# Memorandum to the City of Markham Committee of Adjustment April 28, 2023

File: A/034/23

Address: 163 Fred Varley Drive, Markham

Applicant: ARK Group (Daniel Wong)
Agent: ARK Group (Daniel Wong)
Hearing Date: Wednesday May 3, 2023

DRAWING NAME		Project Location:
Site Plan		163 Fred Varley Drive, Markham, ON
Date	Scale	SHEET NUMBER
Feb. 13/23	As Noted	A000
Project Number	Drawn by	
22002	DW

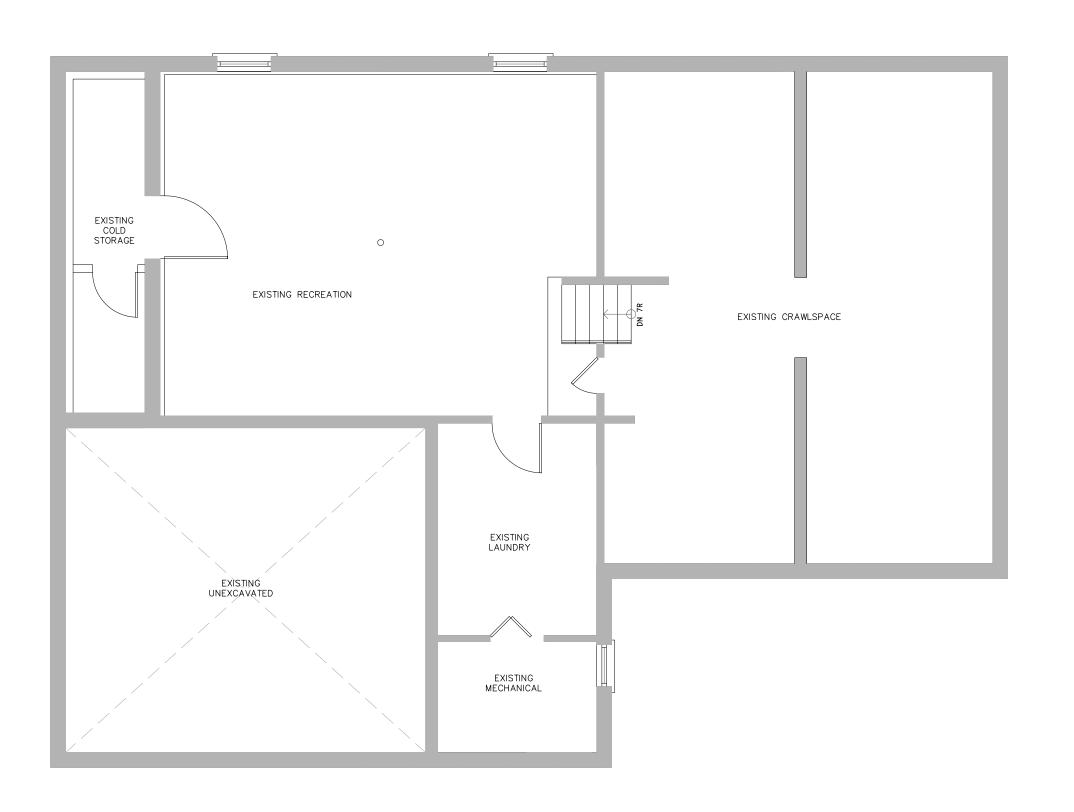
The Applicant is requesting relief to permit a driveway width of 9.96 metres (32 feet 8 inches), whereas the Parking By-law permits a maximum driveway width of up to 6.1 metres, provided a minimum of 40% soft landscaping is provided in the front yard in which the driveway is located.

The current driveway has a width of 5.87 metres (19 feet and 3 inches), whereas the City's Parking By-law 28-97 only permits the driveway width to be 2 metres (6.56 feet) beyond the garage door. As proposed, the requested driveway width is much greater than what the Parking By-law permits.

The proposed variance will result in a loss of soft landscaping area, which will detract from the visual appearance of the neighbourhood. In addition, the increase in hard surfaces will reduce the opportunity for storm water to infiltrate into the ground thereby increasing water runoff into the storm sewer system. However, it should be noted that the Applicant's proposal still maintains the minimum 40% soft landscaping requirement.

Staff have received input from the Operations Department who have expressed concerns with the driveway width at the front yard property line (west property line) and boulevard. The City's Curb Cut Standard Policy would only permit a maximum allowed driveway width of 7.0 metres (22 feet and 11.5 inches) at the front yard property line within the road allowance for this proposed development. This maximum 7.0 metre width, applies to all lands located within the road allowance, which includes the portion of a driveway situated on the boulevard (i.e. the City's grass and sidewalk). Staff note that approval of driveway widening's within the boulevard requires approval from the Director of Operations or their delegate, which is facilitated through a Curb Modification Application.

Staff are <u>not</u> in support of the proposed driveway width of 9.96 metres (32 feet 8 inches) for the entirety of the driveway, as requested by the Applicant and illustrated in Appendix "B" – Plans.

Staff <u>would support</u> a maximum driveway width of 7.0 metres at the front property line, with an appropriate transitional taper from the front property line to a maximum width of 9.96 metres for the purposes of accessing the integrated carport for motor vehicle parking within the carport. Should the recommended variance with driveway tapering be approved, staff recommend that driveway conditions for appropriate tapering and driveway widening's within the road allowance as outlined in Appendix "D", be adopted by the Committee.

- 1. The variance c) apply only to the proposed development as long as it remains:
- 2. That variance c) apply only to the subject development, and that submission of the driveway plans showing the taper layout be reviewed and approved by the City, and that the Secretary-Treasurer receive written confirmation from the Director of Planning and Urban Design or designate that this condition has been fulfilled to his or her satisfaction; and
- 3. Submission of a Curb Modification Application, be reviewed and approved by the City, and that the Secretary-Treasurer receive written confirmation from the Director of Operations or delegate that this condition associated with the Curb Cut Standard Policy for driveway aprons has been fulfilled to his or her satisfaction.
